REVIEW AND APPRAISAL
of the
FISH PROTECTION PROBLEM ASSOCIATED
WITH THE DIVERSION OF WATER AT THE
TRACY PUMPING PLANT,
CENTRAL VALLEY, CALIFORNIA

Fish and Wildlife Service
Region I
Portland, Oregon
June 1953

Figure 7. View of test flume looking downstream. Line of louvers extends from near right to far left of flume.

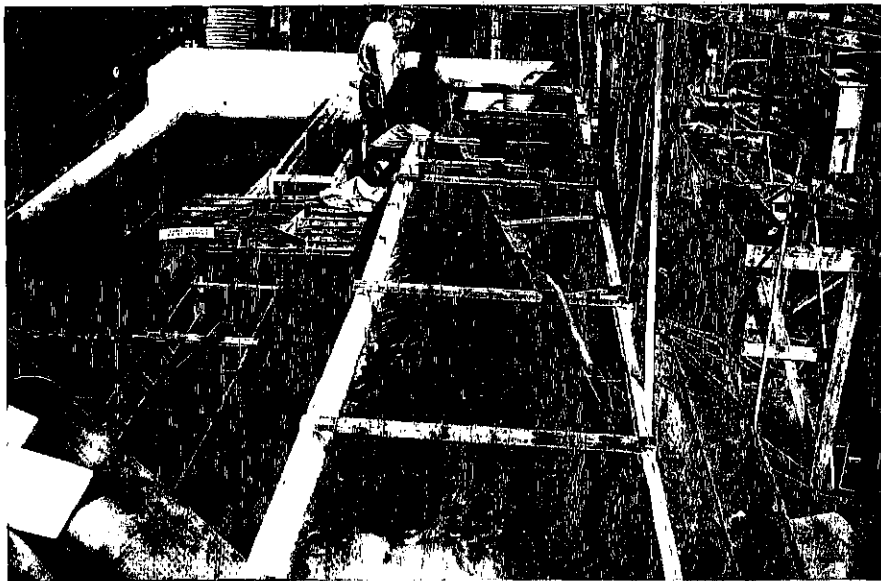
It was recognized that the test flume had certain hydraulic deficiencies and that, although the tests appeared to indicate that louvers might have some merit, additional studies should be conducted on the louver principle before any definite conclusions could be reached.

1. Of sufficient size to accommodate a line of louvers approximately 100 feet in length
2. Velocity of flow in the test flume upstream from the line of louvers as uniform as possible.
3. Ability to change the velocity of flow in the test flume from about 1 foot per second to about 5 feet per second
4. Width of bypass to be approximately 6 inches
5. Ability to change ratio of effective width of test flume to length of line of louvers from approximately 1 to 3.5 to approximately 1 to 15
6. Depth of water in test flume to be 1.5 feet minimum, preferably 2 feet
7. Louver design
 - a. Spacing, not to exceed 4 inches
 - b. Ability to change position or angle of louvers with change in No. 5.

The present experimental flume is not adequate for making a valid test of the practical value of the louver principle for fish-screening purposes. A line of louvers in the prototype structure would need to be hundreds of

feet in length. It is essential, therefore, to know if the reaction of the fish to the louvers would be continually repeated when the fish are exposed to a long section of louvers. The minimum length of a line of louvers that should be used in testing the louver principle is, in our opinion, 100 feet.

FLOW PATTERN IN VICINITY OF LOUVERS

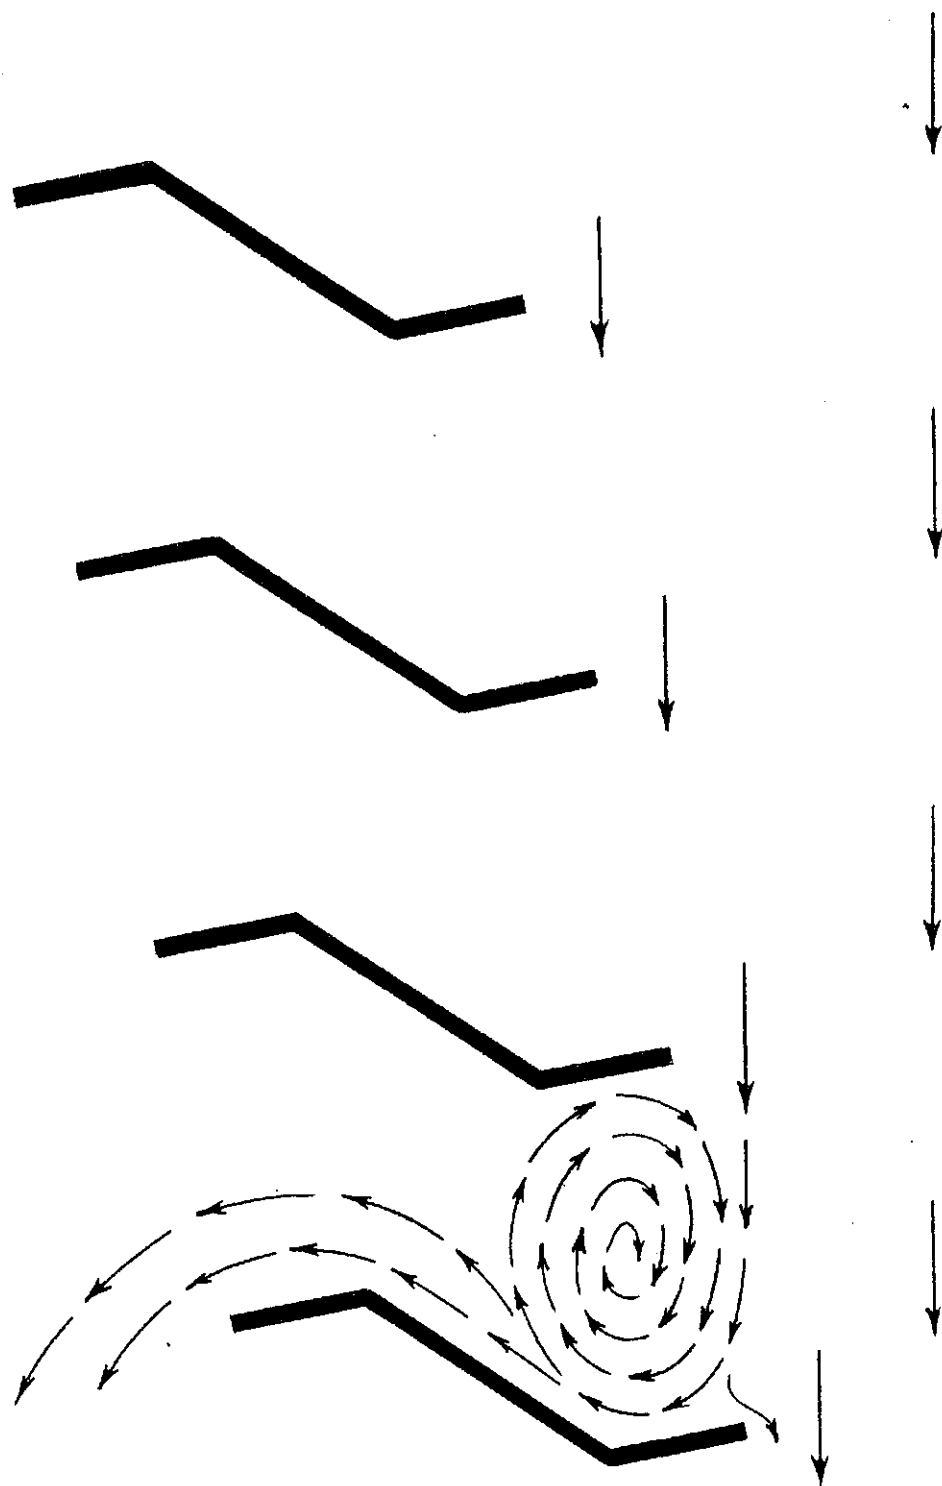
A thorough study has not been made of the hydraulic action of the louvers. However, it appears that the condition desired is for each louver to "peel-off" as thin a slice of water as possible along the upstream surface of the louver (See Figure 8). The most effective cross-sectional shape and position of the louvers, in relation to the direction of flow, should be determined by hydraulic studies.
